SUBJECT: Forwards response to request for addl info re control room
 habitability evaluation.Attachment A to ltr describes 900919
 event & design mods planned. ✓

Subject: Duane Arnold Energy Center
Docket No: 50-331
Op. License No: DPR-49
Response to Request for Additional
Information Regarding DAEC's Control
Room Habitability Evaluation
Reference: Letter, C. Shiraki (NRC) to L. Liu (IELP)
dated August 2, 1991
File: A-107a

RESPONSE TO REQUEST FOR ADDITIONAL INFORMATION

CONTROL BUILDING VENTILATION
(Simplified)

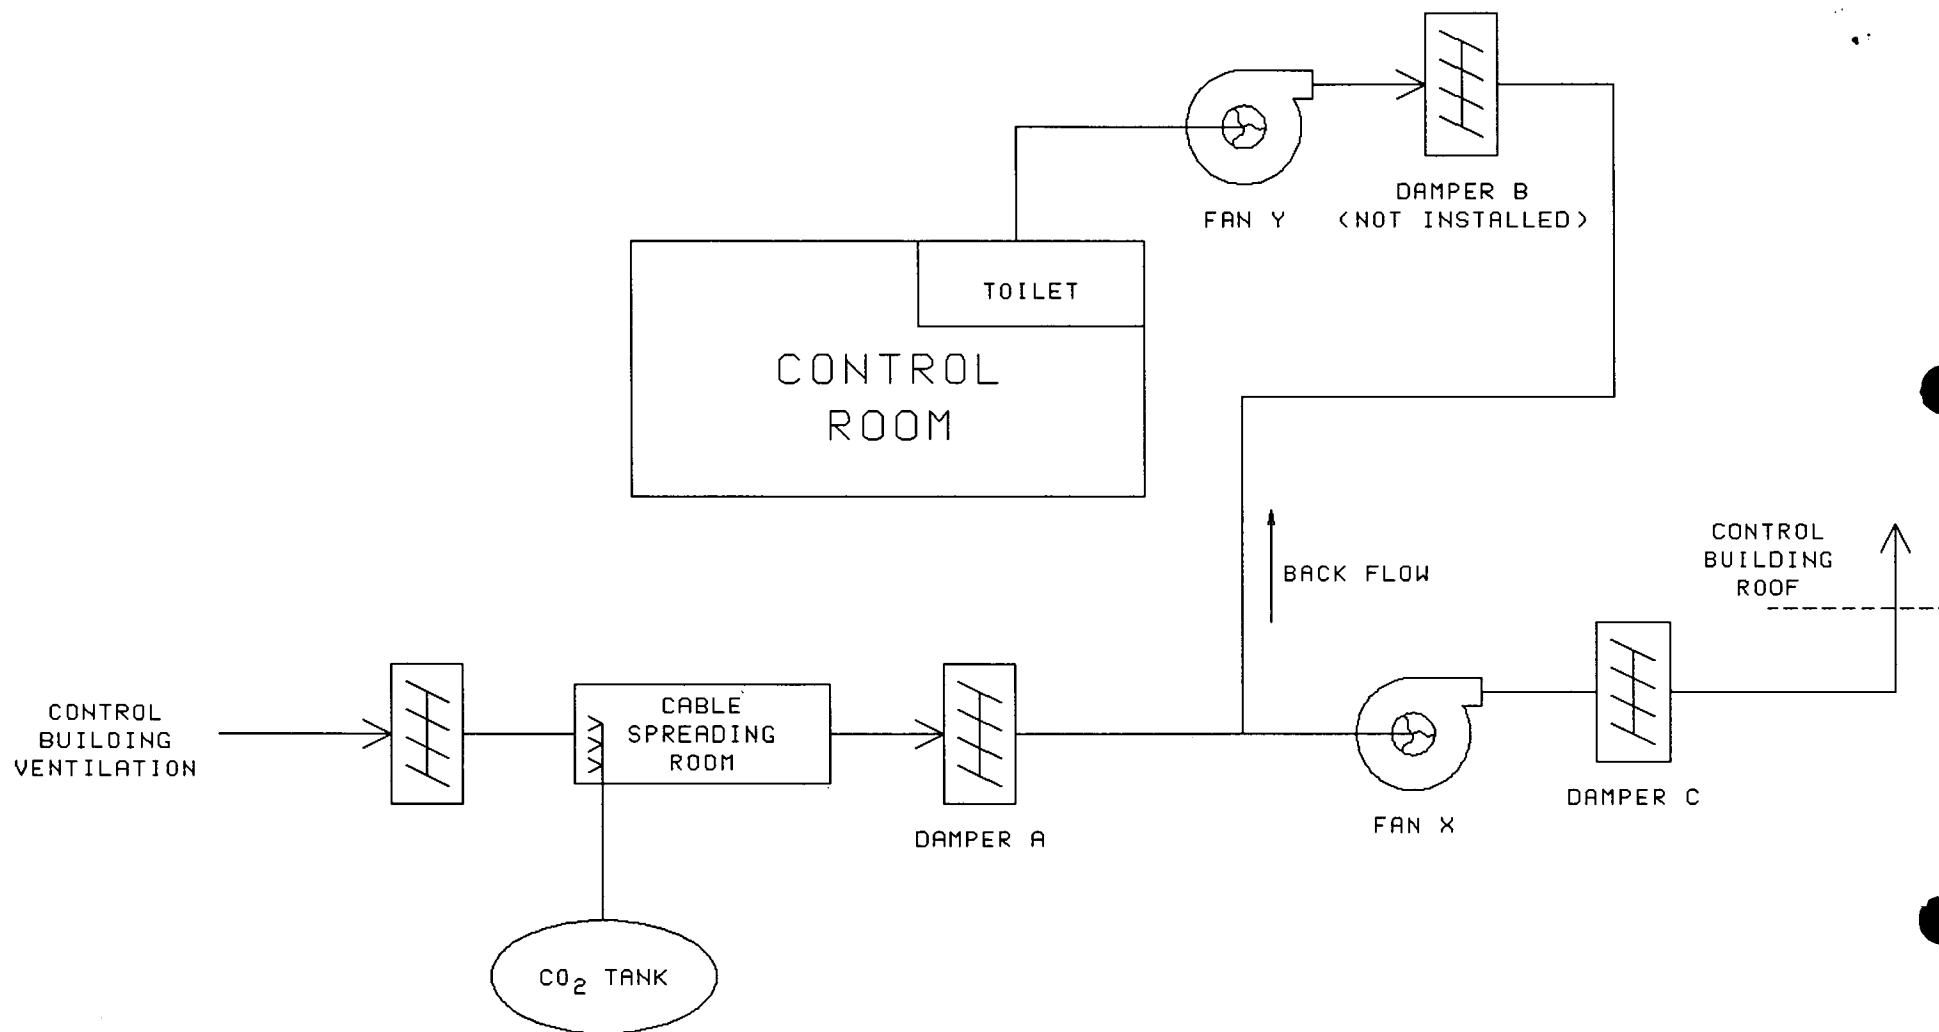
The modifications to the ventilation system were completed in May 1974. Additional fire dampers were installed in the Cable Spreading Room and the CO₂-actuated logic on the room exhaust damper (see Damper A Attachment B) was replaced with 360 degree F fusible links. The exhaust damper would then remain open until the fusible links sensed an actual fire (360 degrees F) thereby maximizing the availability of a vent path to prevent overpressurization of the Cable Spreading Room.

It was during the investigation of the September 19, 1990, event that we identified that the backdraft damper (see Damper B) which was intended to prevent air from backflowing into the Control Room from the Cable Spreading Room was never installed. Design documentation has always reflected a damper in the line and consequently, its presence was assumed in the later habitability evaluations. Despite vigorous efforts, we are unable to explain its absence. Additionally, we determined that upon CARDOX actuation, the room exhaust fan (see Fan X) secures and the fan's discharge damper (see Damper C) closes, effectively blocking the intended vent path. Therefore, the 1974 ventilation modifications were ineffective in that a CARDOX initiation can still pressurize the Cable Spreading Room and, without the backdraft damper, CO₂ can backflow into the Control Room.

Design modifications have been initiated which will address the backflow through the control room exhaust fan (see Fan Y) and ensure the proper venting of the Cable Spreading Room in the event of a CARDON initiation. These design changes will be complete prior to shutdown for the Cycle 11 refueling outage. Additionally, post-modification testing will be performed during the Cycle 11 outage to verify the effectiveness of these modifications. Upon successful completion of this testing, the Control Room habitability evaluation described in UFSAR Section 6.4 will be revised to reflect the analysis of and corrective actions resulting from the September 19, 1990 event.
